Addendum No.: 4

Date of Addendum: June 17, 2020

Willard Diloreto Parking Garage
Paul Manafort Sr. Drive
New Britain, CT
CF – RC – 402

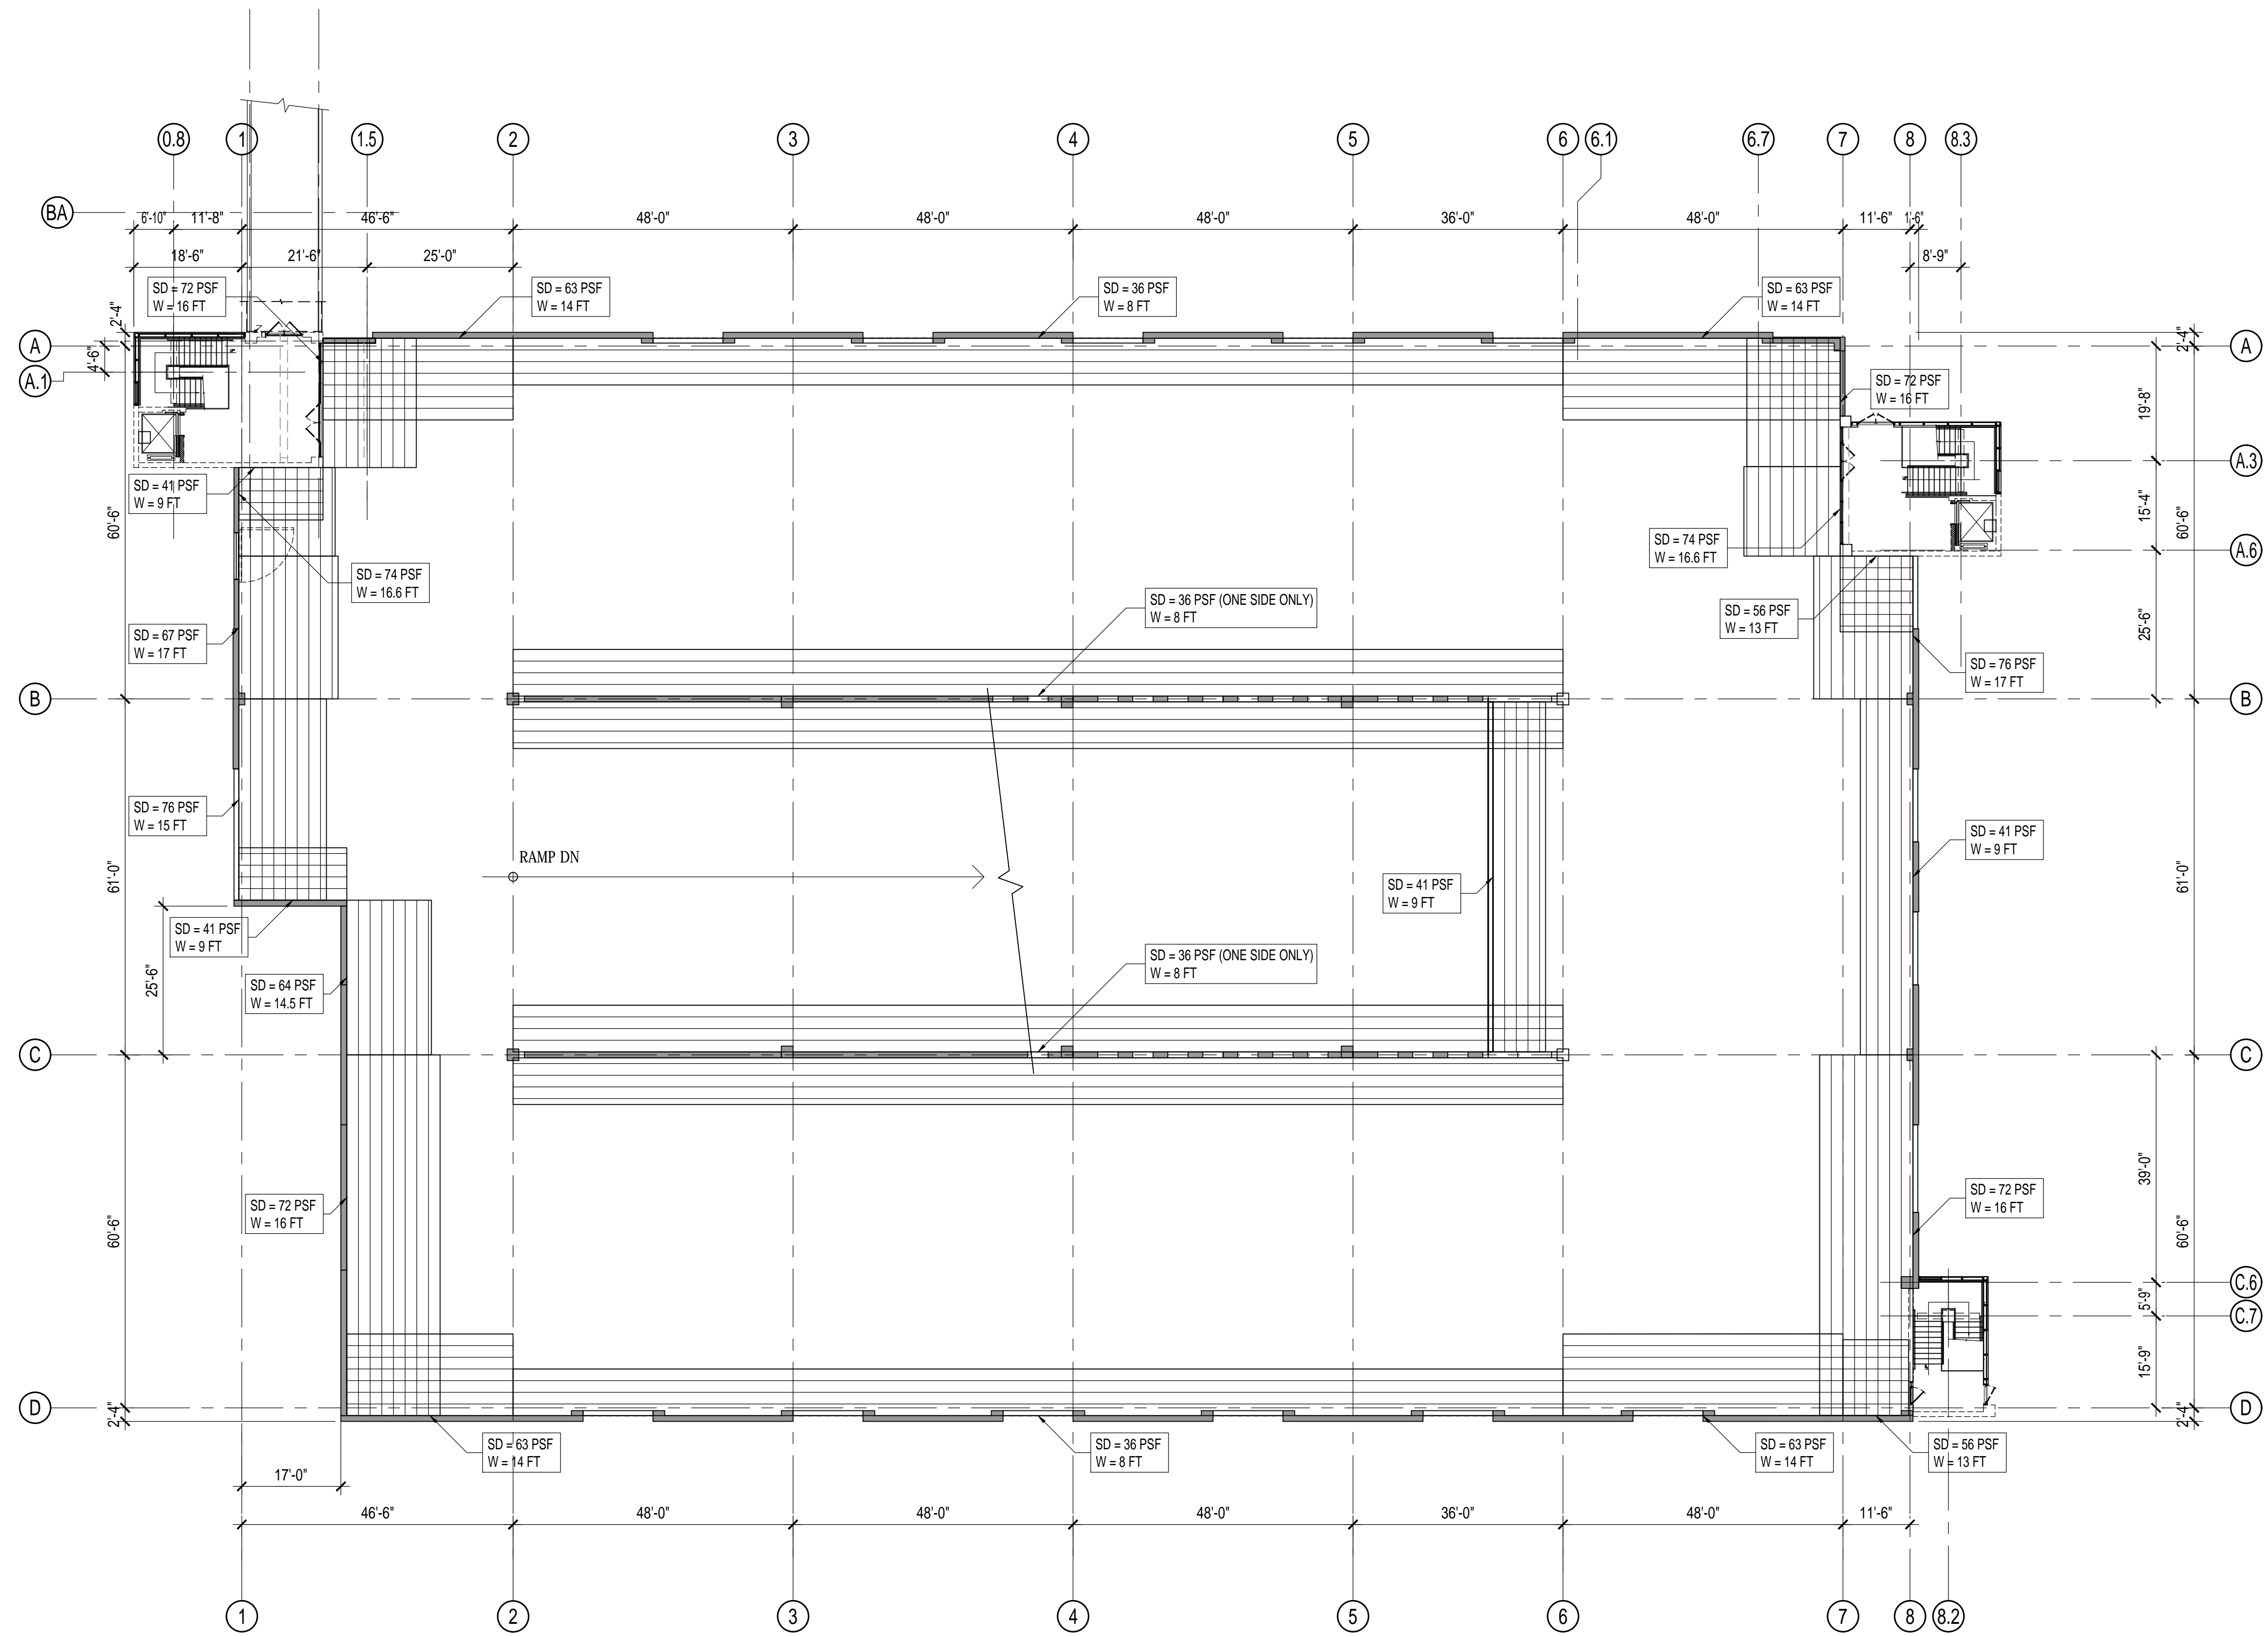
Question: Drawing S001 - Design Criteria - Addendum #3 RFI # 23 addressed (Snow Load) as one of the missing loads, but it did not mention the missing Base Shear Loads. Please provide all necessary loading per the Connecticut State Building Code Section 1603.

Answer: See added drawings S005 and S006 for Loading Diagrams for foundations and snow drift.

1 SECOND LEVEL FRAMING PLAN
 SCALE: 1/16" = 1'-0"

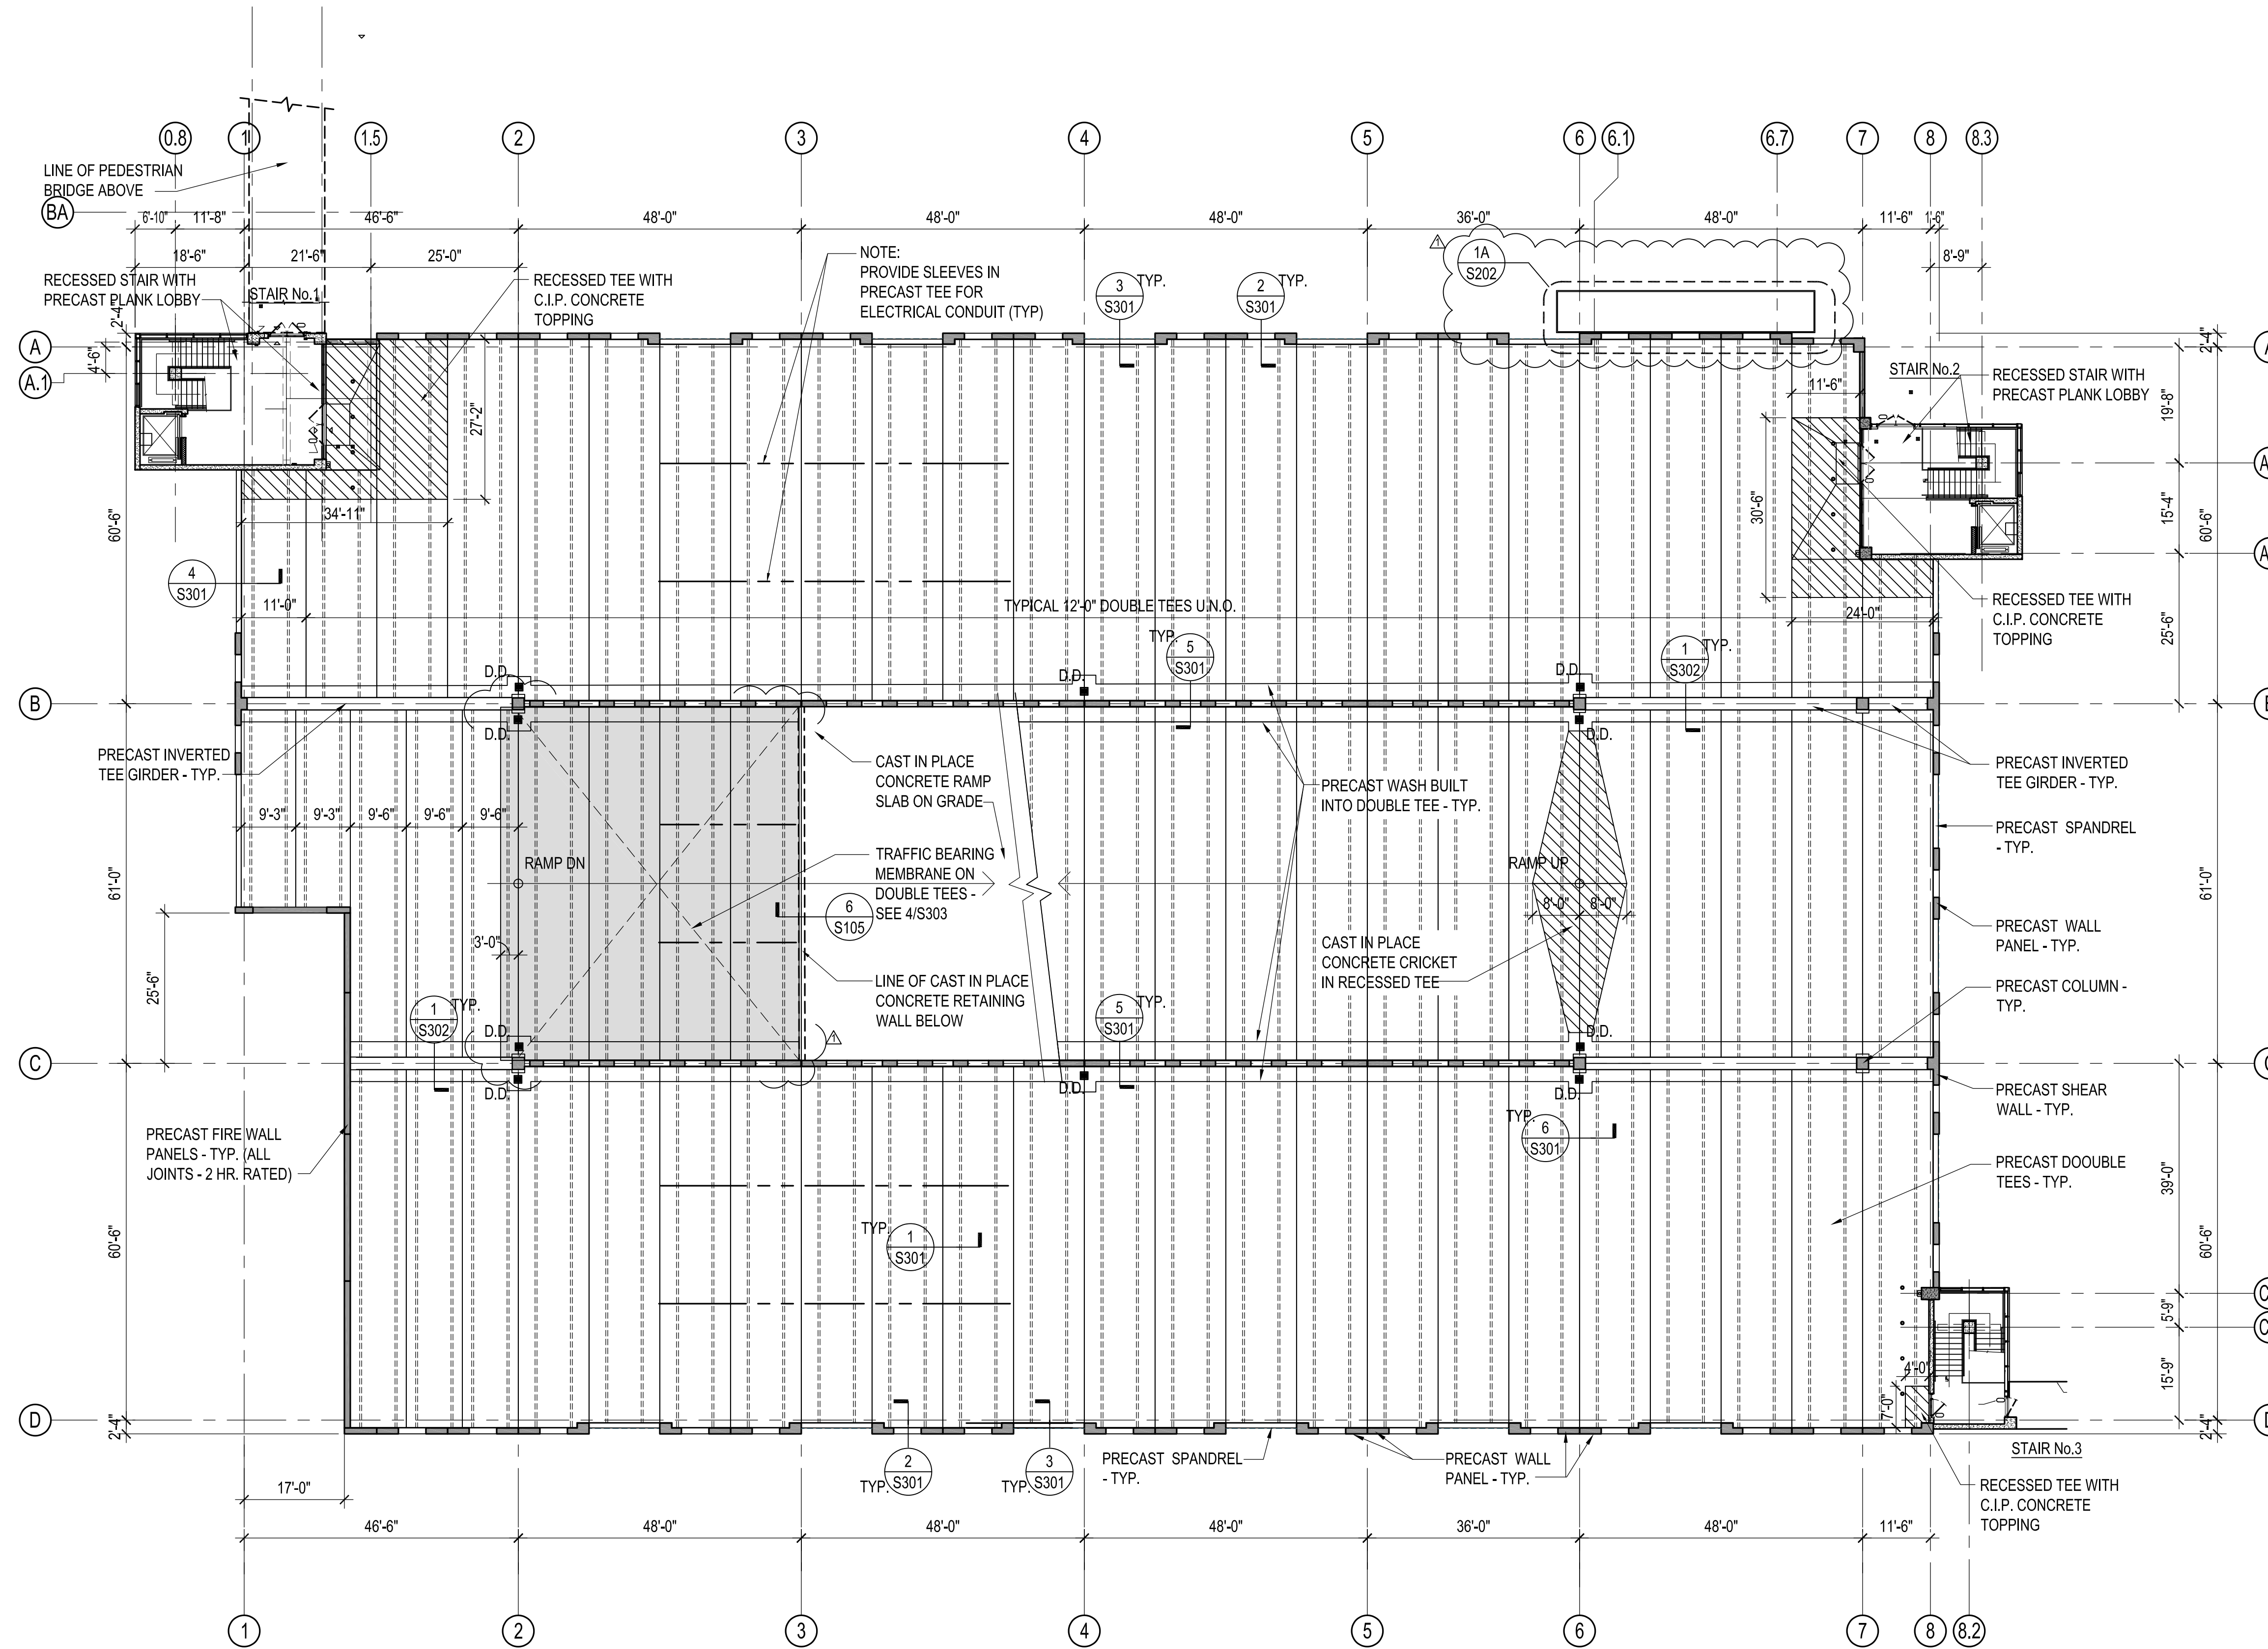
Question: Dwg A205. Please provide corresponding structural drawings and member sizes for canopy structure.

Answer: See revised drawing S202 with Canopy Framing structural details added.
